DEVELOPMENT DETERMINATION PANEL MEETING

WEDNESDAY 25 OCTOBER 2023

**Agenda for a Meeting of the Development Determination Panel
to be held on Wednesday 25 October 2023
via teleconference
Commencing at 10:00 AM**

Figure 1 - Section plan showing extent of height breach

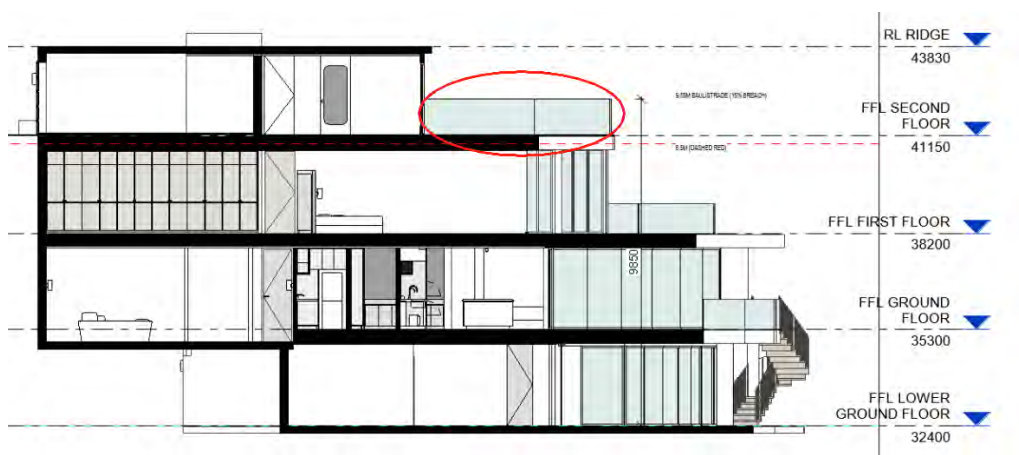
Development standard:	Height of buildings
Requirement:	8.5m
Proposed:	9.85m
Percentage variation to requirement:	15.88%

Figure 3 - West elevation showing envelope breach in red

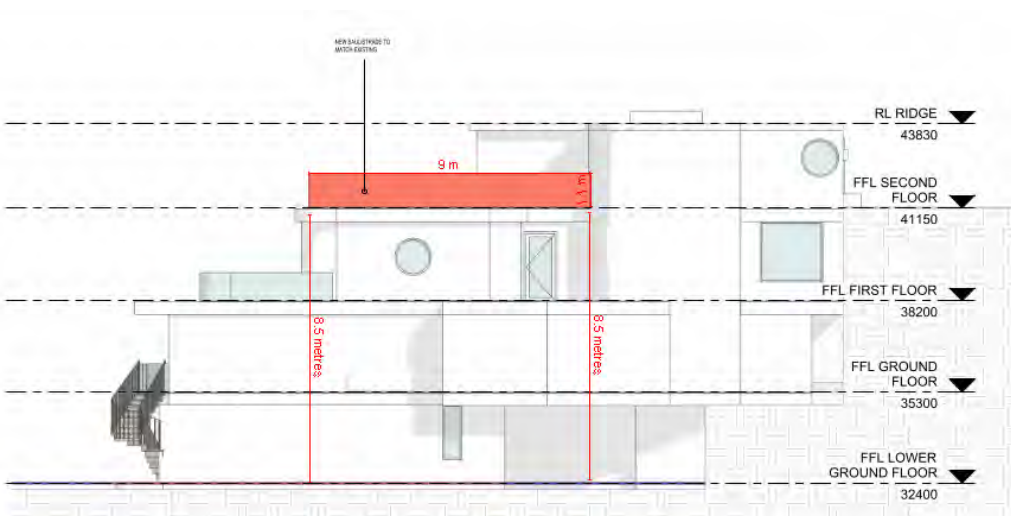
It is noted that the the encroachment occurs as a result of the new balustrades to the second floor terrace.

Above: The extent of the breaches to the height of buildings development standard, shown in yellow.

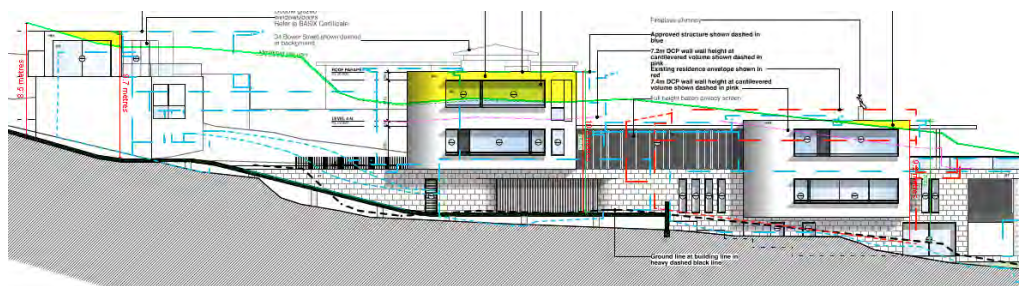
Development standard:	Height of buildings
Requirement:	8.5 metres
Proposed:	Building 1: Max. 9.4 metres Building 2 & 3: Max. 10.78 metres Building 4: Max. 9.2 metres
Percentage variation to requirement:	Building 1: 14.12% Building 2 & 3: 26.82% Building 4: 8.23%

Figure 1 - Extract from Section 1 (Drawing No. DA3000, Rev. 1, dated 3 October 2023) depicting building height.

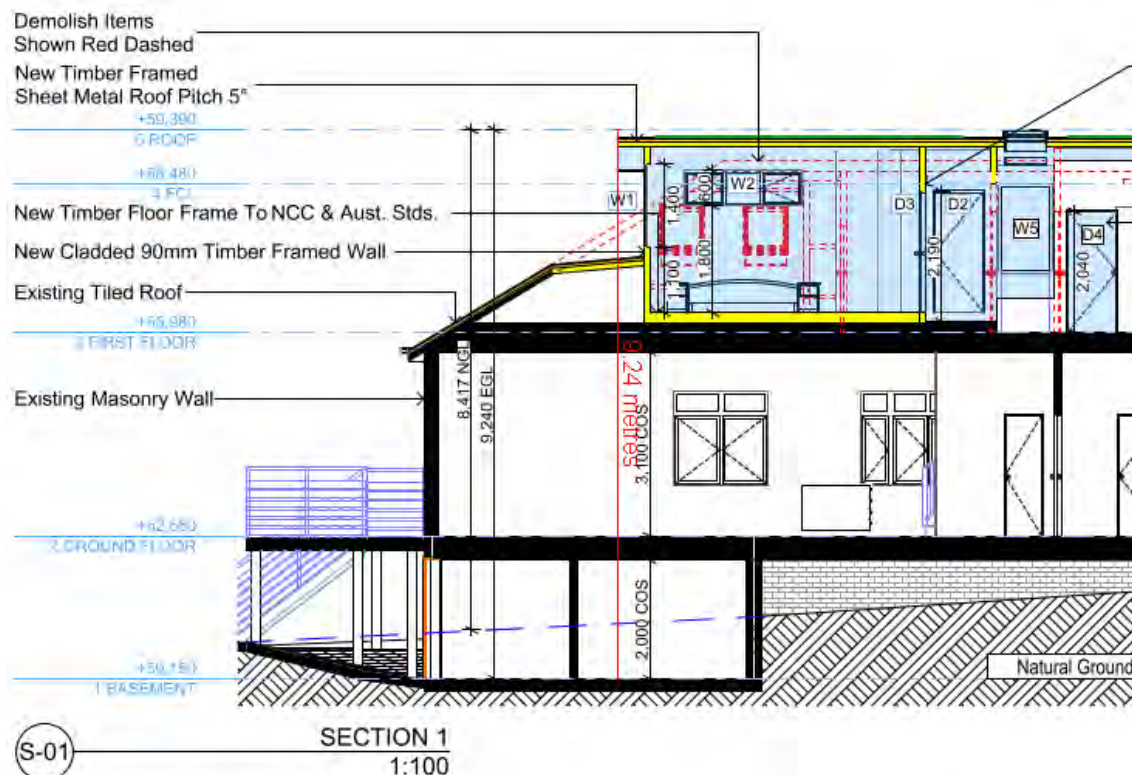
Development standard:	Height of buildings
Requirement:	8.5m
Proposed:	9.24m
Percentage variation to requirement:	8.7%

Above: The extent of the building height non-compliance, marked in yellow.

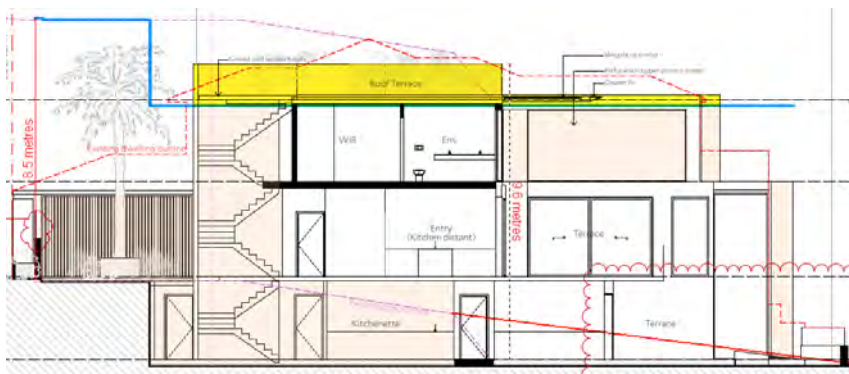
Development standard:	Height of buildings
Requirement:	8.5m
Proposed:	9.6m
Percentage variation to requirement:	13.53%

Figure 1. Building height non-compliance

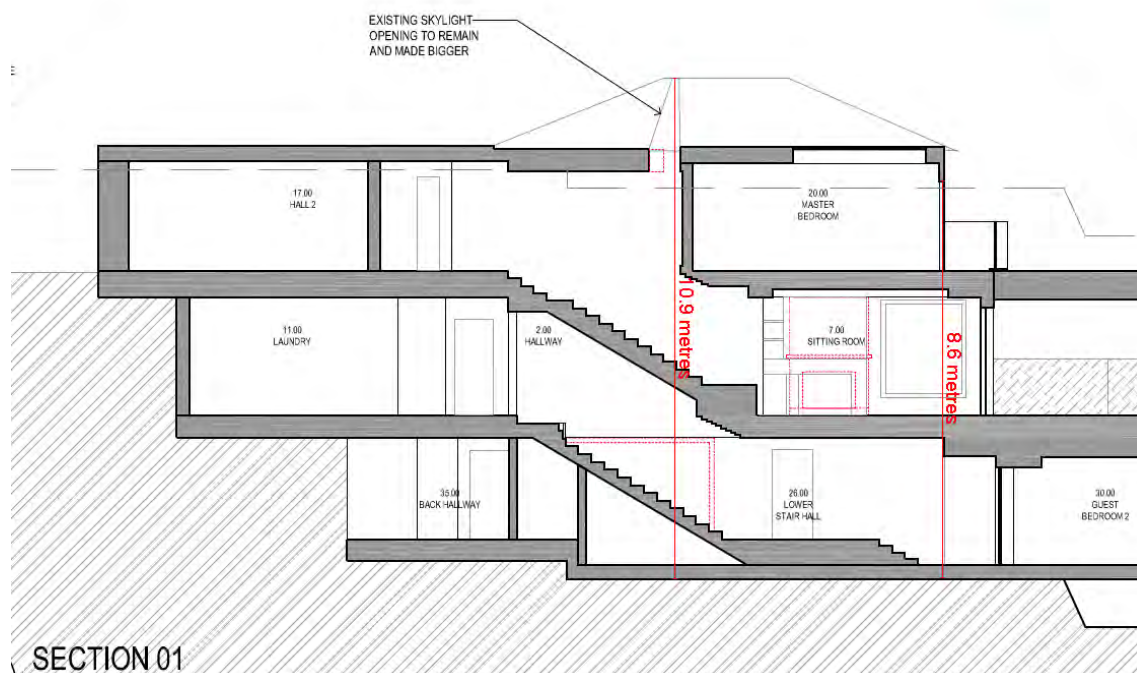
Development standard:	Height of Buildings
Requirement:	8.5m
Proposed:	10.93m
Percentage variation to requirement:	28.6%

Figure 2. L1 gym side setback non-compliance.

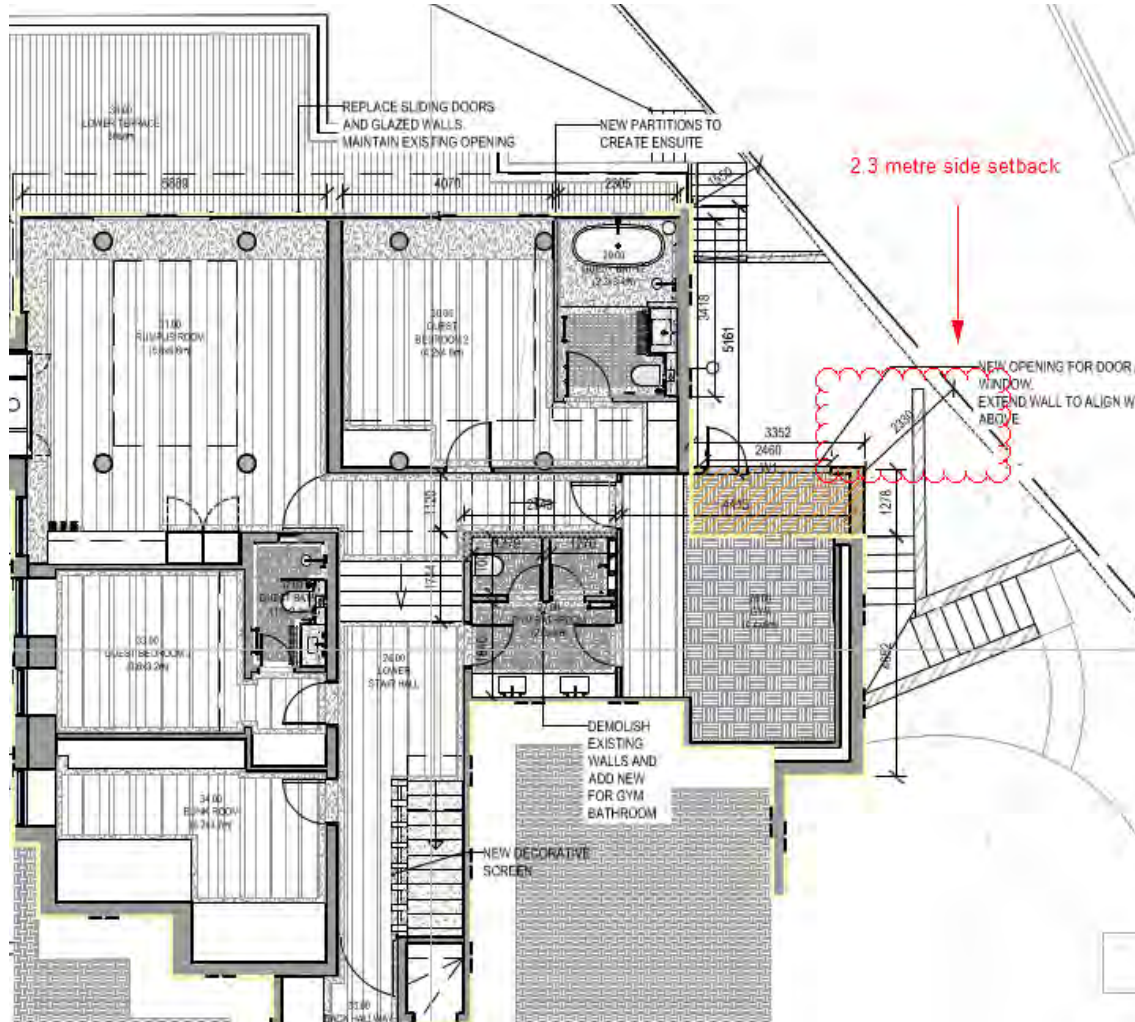
The site is highly irregular in shape and has a number of site constraints to design around including the steep gradient of the land. In addition, the proposed pergola will be constructed above the existing terrace, which is sited 1.5 metres from the eastern boundary. The variation to the setbacks is diagrammatically displayed below.

Figure 5: *Resultant additional soft landscaping areas recommended via conditions of consent*

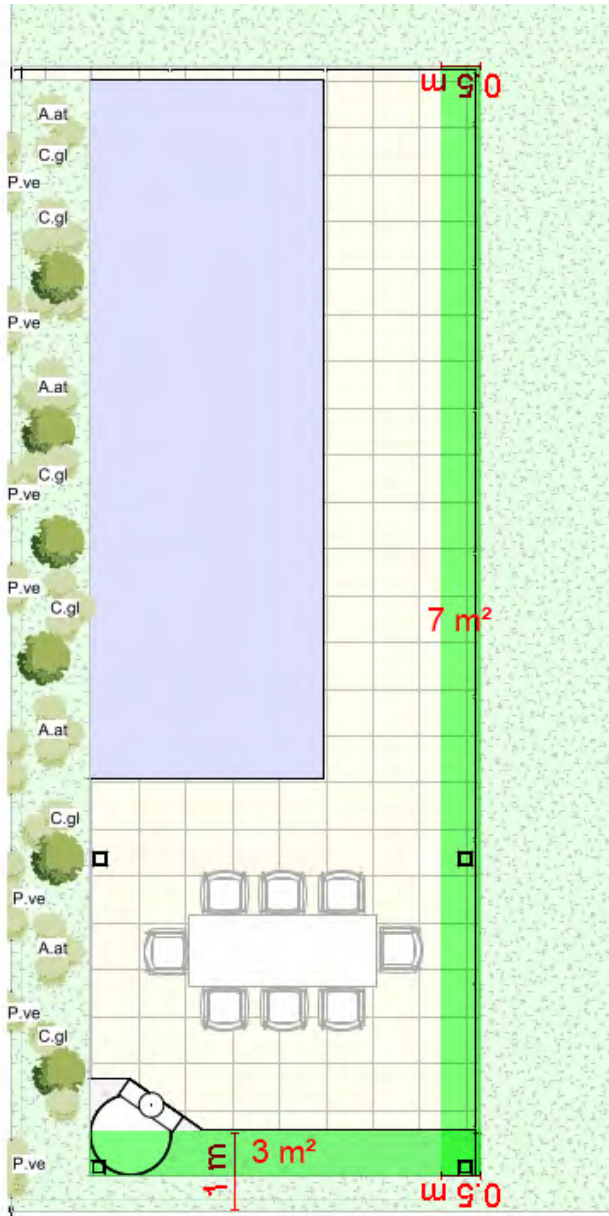
This in addition to the condition recommended under Clause D10.8 to increase the southern side setback of the pool deck, shall suitably increase the landscaped area to an extent that there will be no net less from the existing arrangement.

SECTION A HEIGHT ANALYSIS

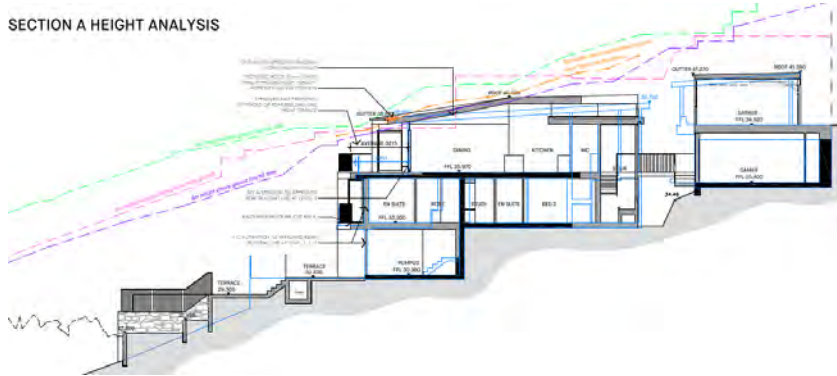
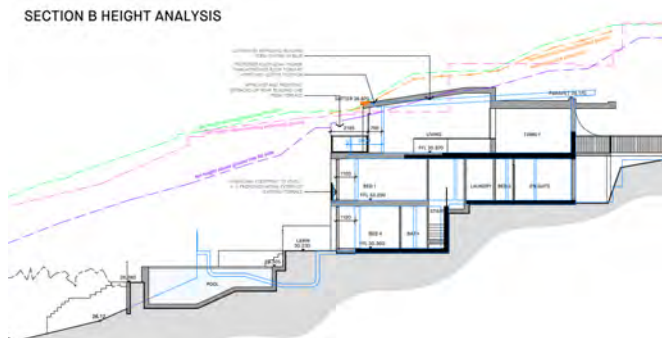
- The overall height of the south-eastern extremity of the new roof would be reduced by 80mm (from RL38.950 to RL38.870). This will reduce the height breach on this portion of the dwelling to a maximum of **8.37m** above extrapolated ground levels.
- The proposed modifications will extend the proposed roof to the south (down-slope) by up to 1.2m. This will result in the proposed roof over the upper floor living and dining room having maximum height of 8.3m above extrapolated ground levels. This is depicted in Figure 1 and 2 below. The remainder of the additions will comply with the 8.0m requirement from extrapolated ground levels.

Figure 1 - Proposed additional building envelope non-compliance on the north-eastern elevation (highlighted in dark blue). Green represents areas of reduced built form.

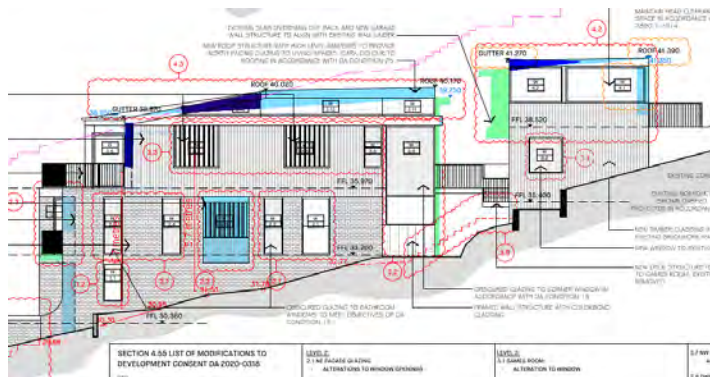
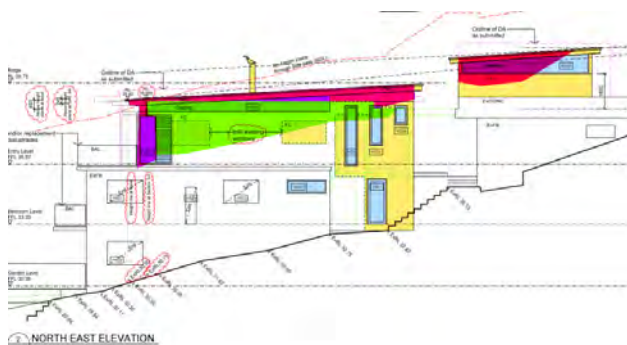
The subject modification includes works which protrude outside the prescribed building envelope along the north-eastern elevation. The works also include a reduction to approved building envelope non-compliance along this elevation. Figure 1 represent additional envelope encroachment subject of these modifications (highlighted in dark blue). Figure 2 represents the approved envelope non-compliance along the north-eastern elevation (as approved within DA2020/0318).

This building envelope non-compliance is largely attributed to the slope of the site and the existing built form which currently has an building envelope breach on this elevation.
